Appendix C-3

Response to comments of the national Fish and Wildlife Service, August 4, 2015 on SAJ-2004-12518 (SP-JCM), for the St. John Marina - Summer's End Marina in Coral Harbor on St. John

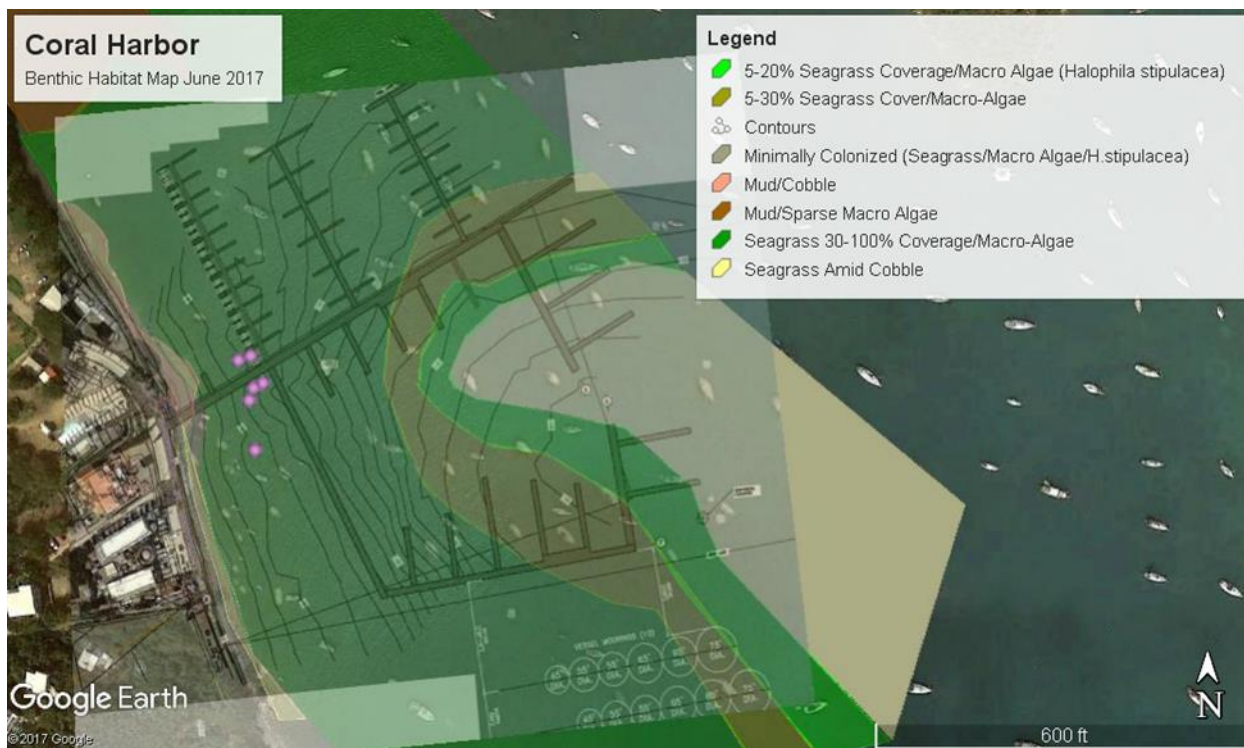
1. The applicant should address all direct and indirect impacts of the project to sea grasses within the project limits.

Type	Habitat	Number	Acres	Sq. ft.
Moorings	30-100% Coverage Seagrass	9 (8 +0.5,0.5)		
Moorings	5-30% Coverage Seagrass	3 (1.5 + 1.5)		
	Total	12		
Docks			1.69	73,591.10
	Riprap (above MHW)		0.01	235.00
	Docks Less Above MHW		1.68	73,356.10
	Mud/Cobble		0.02	762.20
	30-100% Coverage Seagrass		0.90	39,258.18
	5-30% Coverage Seagrass		0.48	20,927.41
	5-20% Coverage Seagrass Macro-Algae		0.13	5,836.21
	Minimally Colonized		0.15	6,572.10
	Total		1.68	73,356.10

A total of 39,258.18sq.ft of docks are over areas with SAV, the majority of which has densities between 20 and 100%. Based on a 46% survival due to shading since the Applicant is using grated decking, 21,199.42sq.ft. (0.487ac) of seagrass may be lost. At the maximum capacity and at the maximum size boat in each slip there will be 5.65 acres of shading due to vessels. It can be assumed that 50% of this will be lost due to vessels being in placed more than 2 weeks at a time. There will be some survival due to angle of the sun and vessel types and some available light. There will be impacts due to spudding impact during construction which will probably account for between a 900-1020sq.ft of impact (6sf per spudding event and between 150 and 170 relocations. The operation of the marina will have an impact due to prop wash scour and you can assume another 10% loss. In total, approximately 3.75 acres of seagrass will probably be lost as a result of the project.
